Subject: Revisions to CESSAR-F

- Attachments:
- (A) CESSAR-F Revision for Removal of the Safety Injection Nozzle Thermal Sleeve.
 - (B) CESSAR-F Revision for Removal of the CEA Guide Tube Brackets.

Attachment A

CESSAR-F Revision for Removal of the
Safety Injection Nozzle Thermal Sleeve

5.4.3 REACTOR COOLANT PIPING

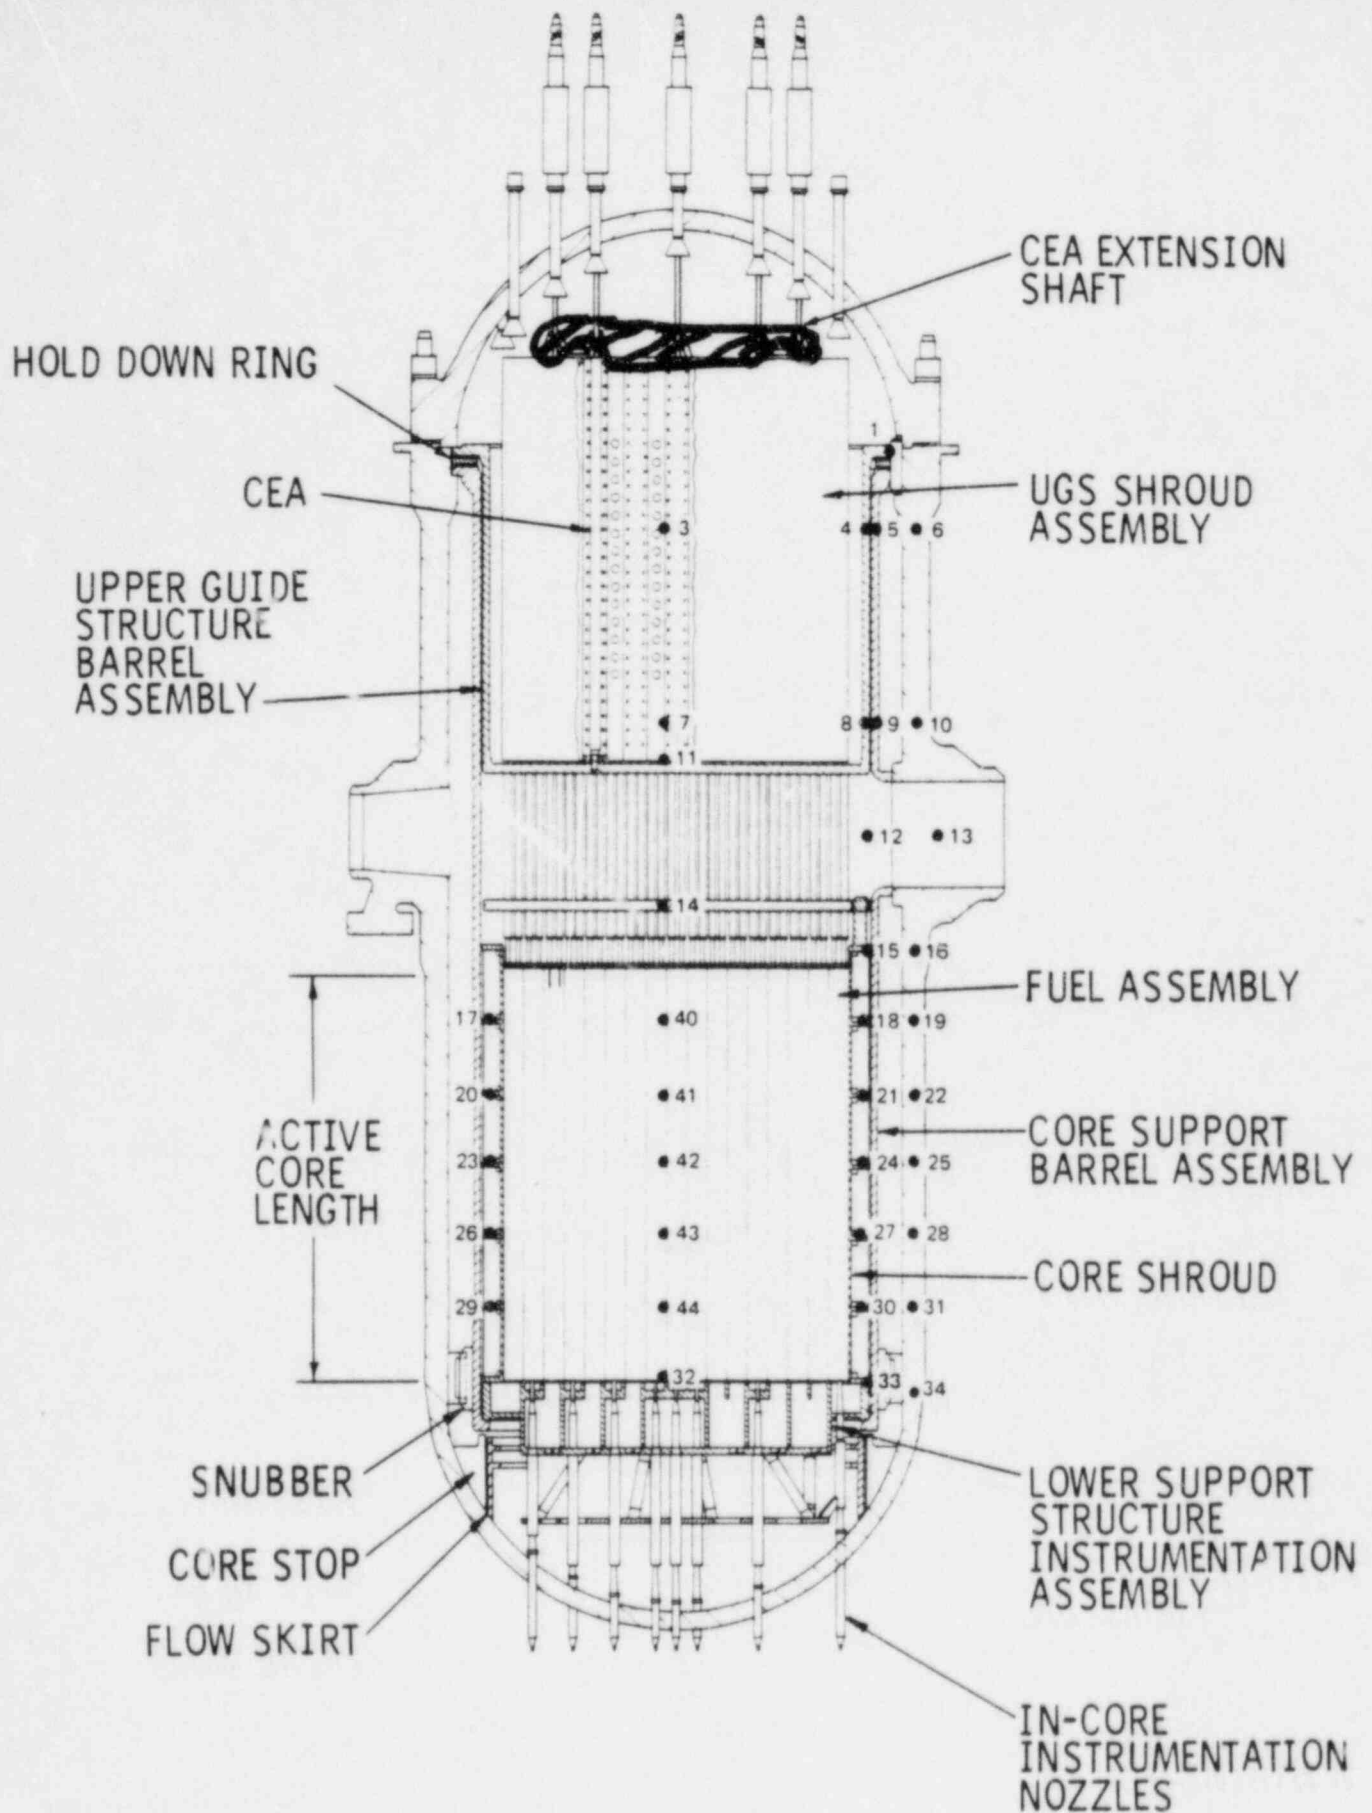
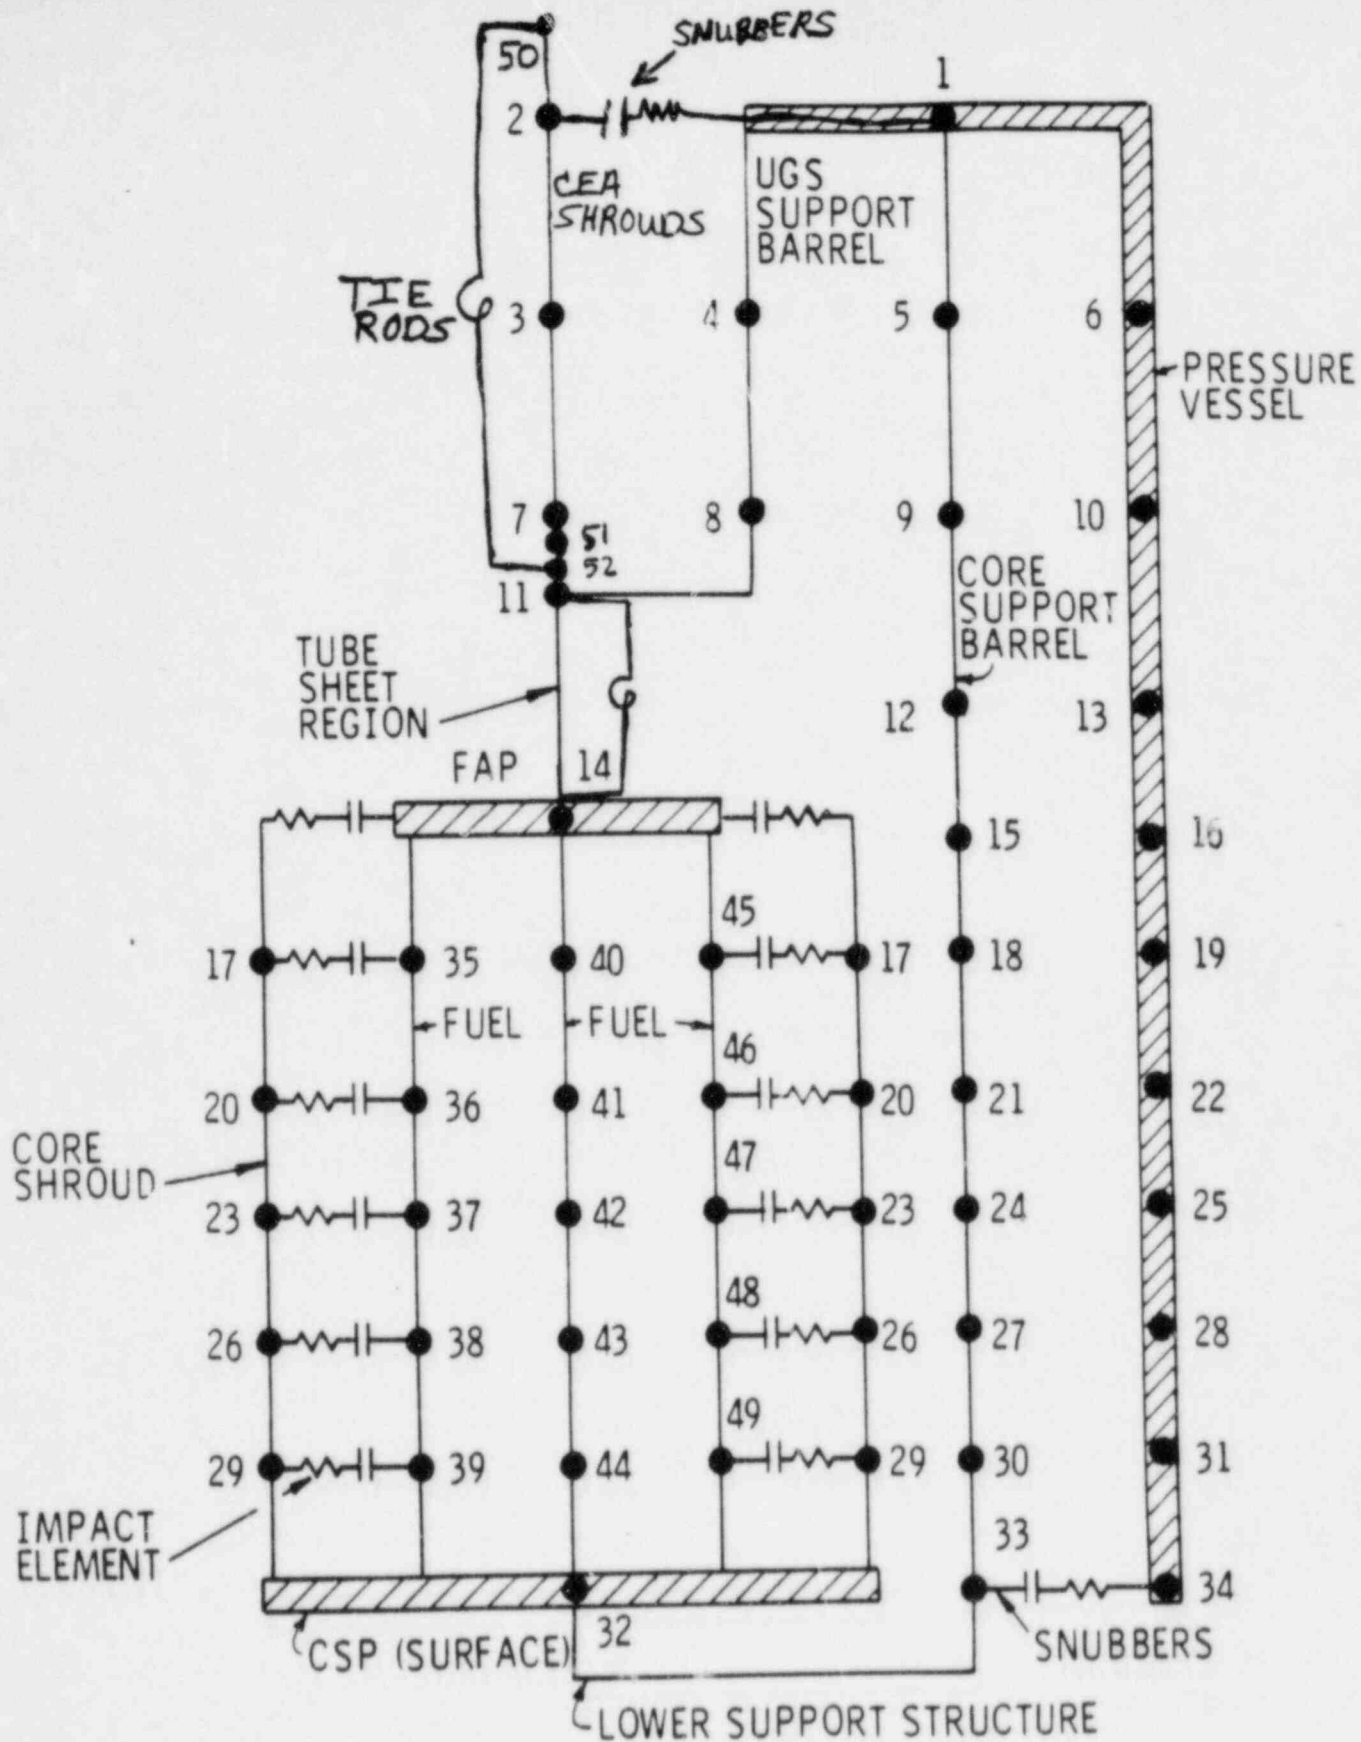
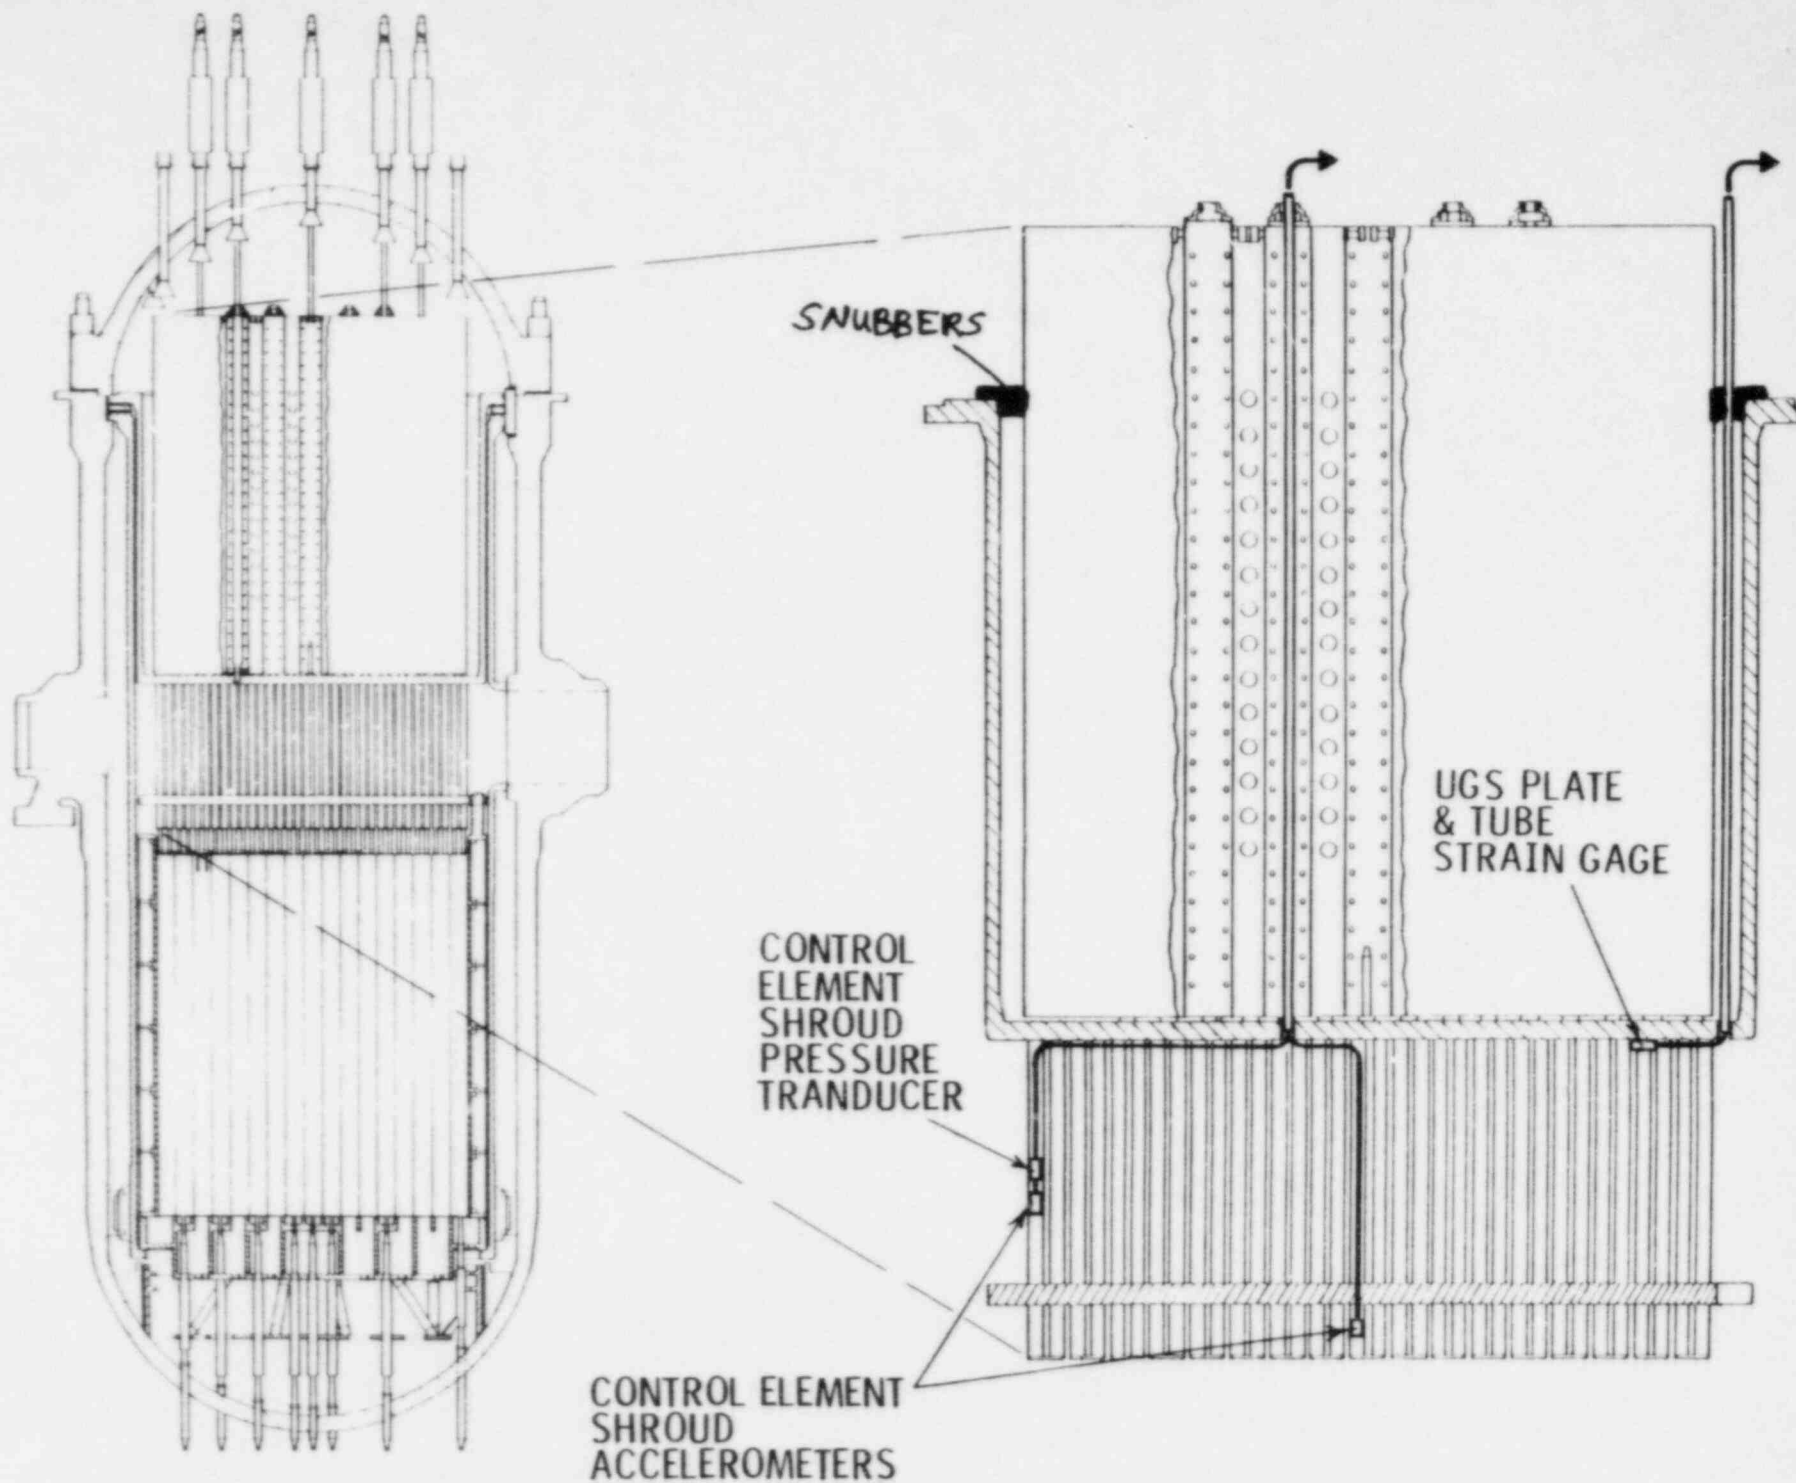
The nozzle thermal sleeves are referred to in Section 5.4.3 of CESSAR-F. Since the safety injection nozzle thermal sleeves are not required, specific mention of thermal sleeves has been removed from Section 5.4.3. A sentence has been added to state that nozzles are analyzed to ensure that the expected transients can be accommodated. This revision is provided in Attachment (A).

~~In addition, certain nozzles are subjected to local transients which are included in the design and analysis of the areas affected. Thermal sleeves are installed in the surge nozzle, safety injection nozzles and charging nozzle to accommodate these additional transients.~~

In addition, those nozzles subjected to local thermal transients, caused by fluid entering the Reactor Coolant System from an auxiliary system, are analyzed to ensure that the nozzles can accommodate the additional transients.

Figure
 3.9.2.11

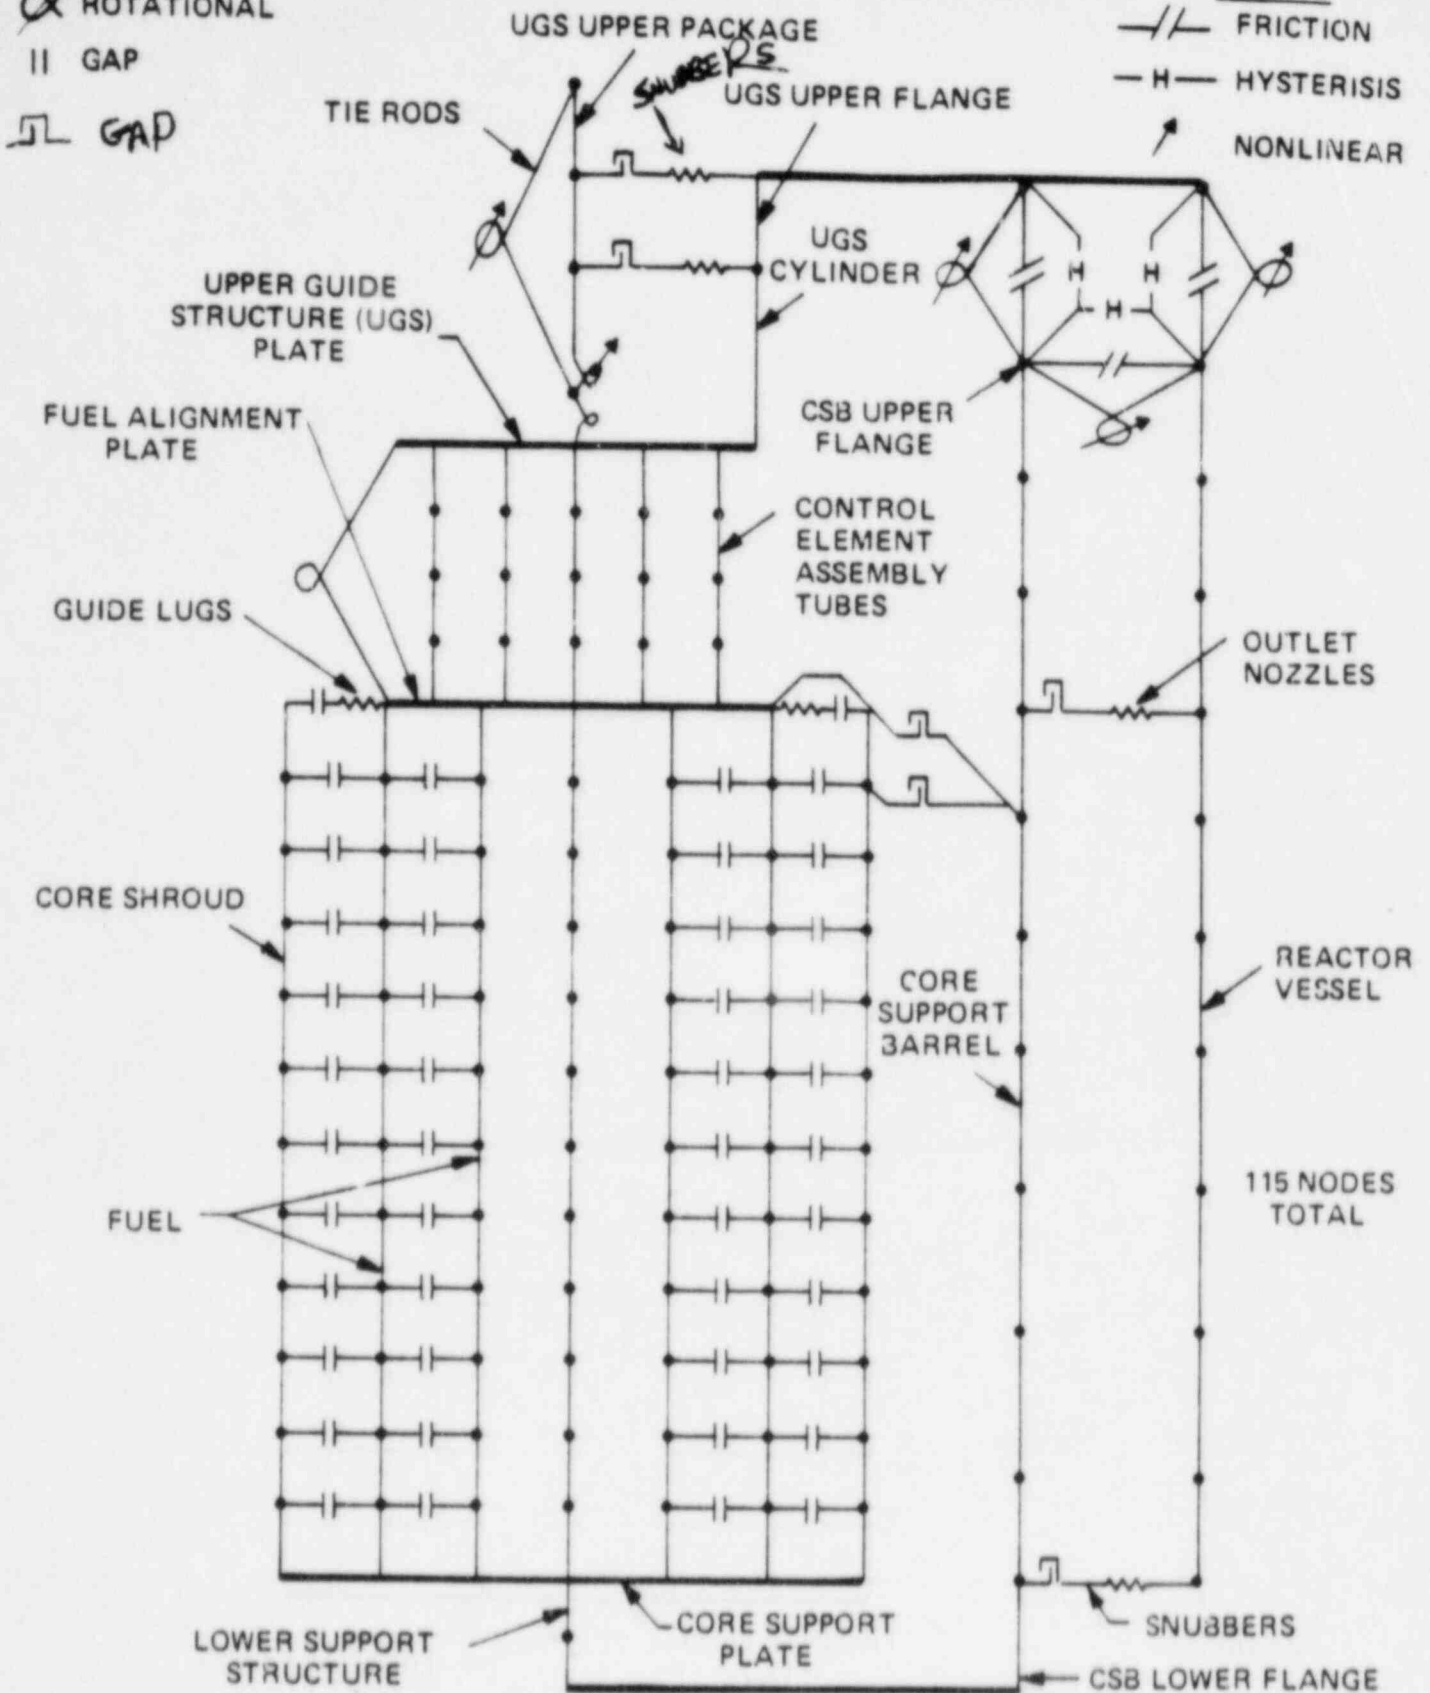
Inspection of reactor internals after pre-core hot functional testing at Palo Verde 1 showed that the CEA guide brackets, located at the top of the upper guide structure, were susceptible to vibration cracking [Reference (5)]. This problem was resolved by removing the guide brackets and placing snubbers between the upper guide structure barrel and the CEA shroud structure, as indicated in Attachment (B). The CEA guide brackets served to align the CEAs and extension shafts only during assembly and disassembly of reactor internals.

The mechanical design and seismic analysis of the reactor internals are described in Sections 3.7 and 3.9 of CESSAR-F. Revisions to these sections are provided in Attachment (B).

movement of the vertical tube and plate assembly is minimized by four snubbers symmetrically located between this assembly and the top of the UGS support barrel.
